8/8A St Georges Mews  
London, NW1 8XE

Basement Impact Assessment  
Audit

For  
London Borough of Camden

Project Number: 12466-53

Job	Title	Date	Scale	Number
St George's Mews	Location (Block) Plan	13.02.17	1:100 at A3	1606/ P-10

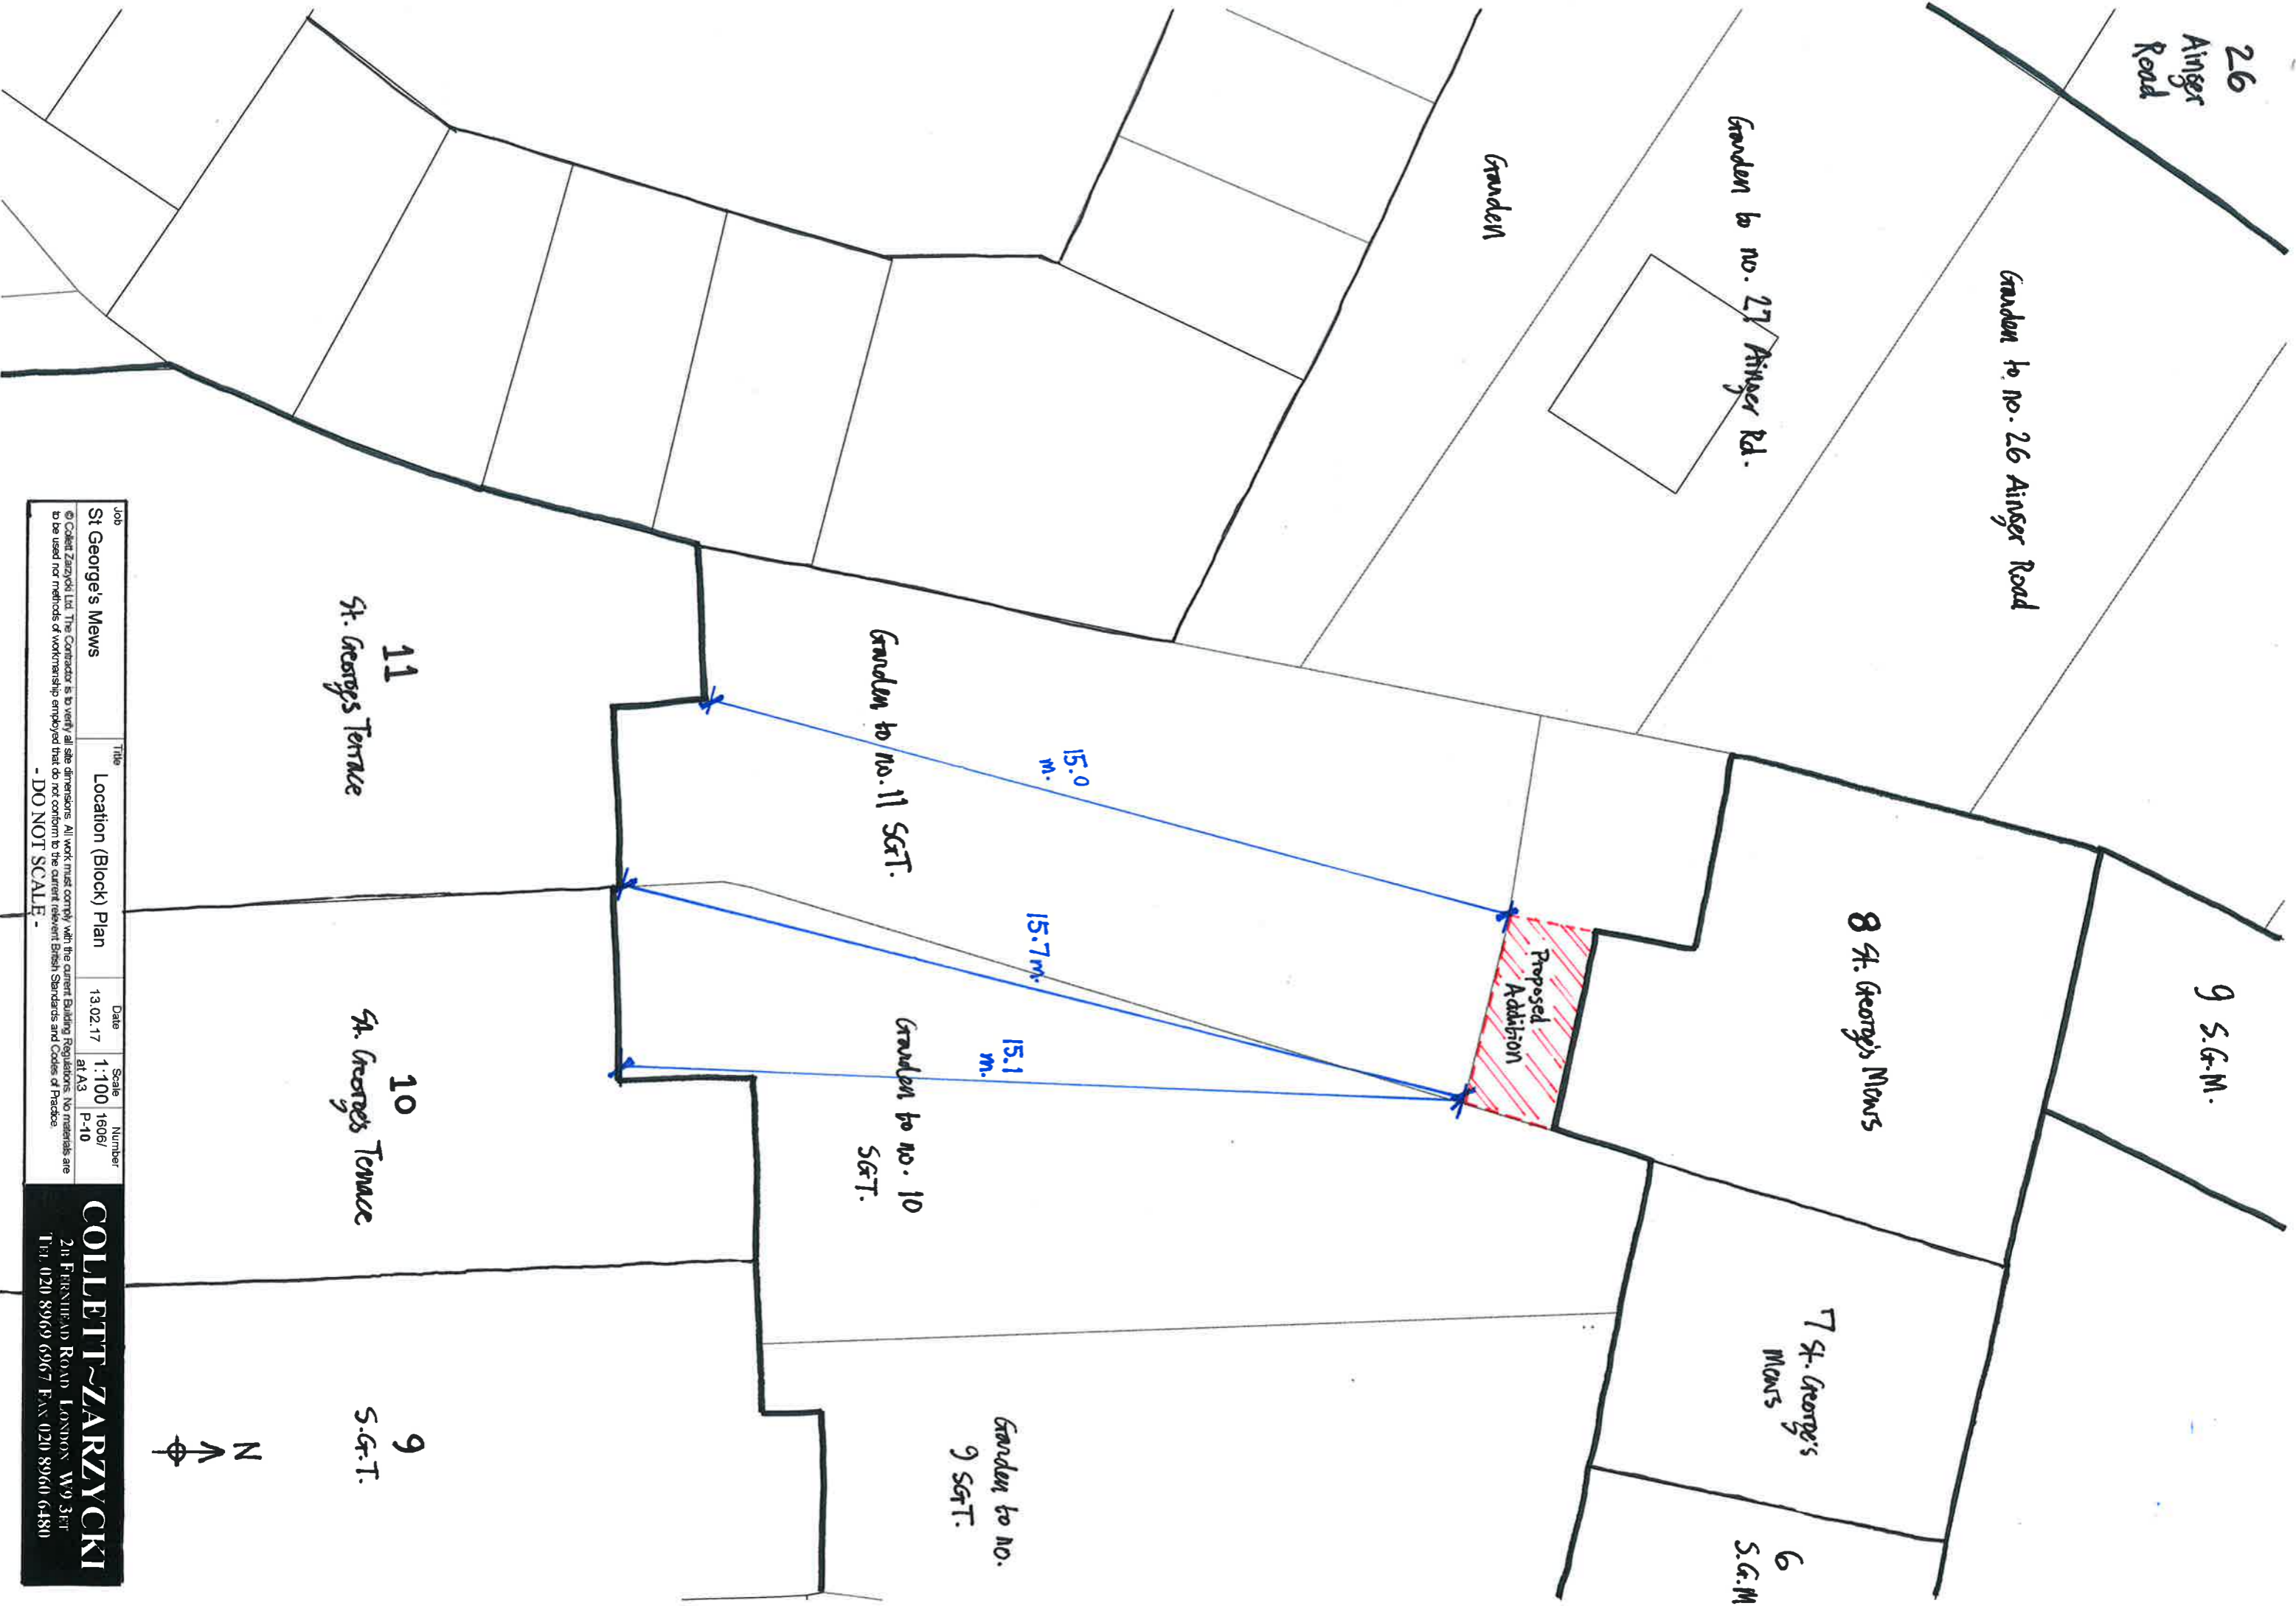
- 4.6. It is noted that no ground movement assessment or damage impact assessment is presented, as no structures exist within the zone of influence of the development's excavation / construction effects. The closest structure is some 8m to 9m away from the proposed retaining wall; garages to the rear of 29 Ainger Road, more than 4 times the height of the planned retaining wall (<2m). It is accepted that structural monitoring is not required and the development will not impact land stability.

P-10\_Plan (marked up with dimensions to neighbouring structures).
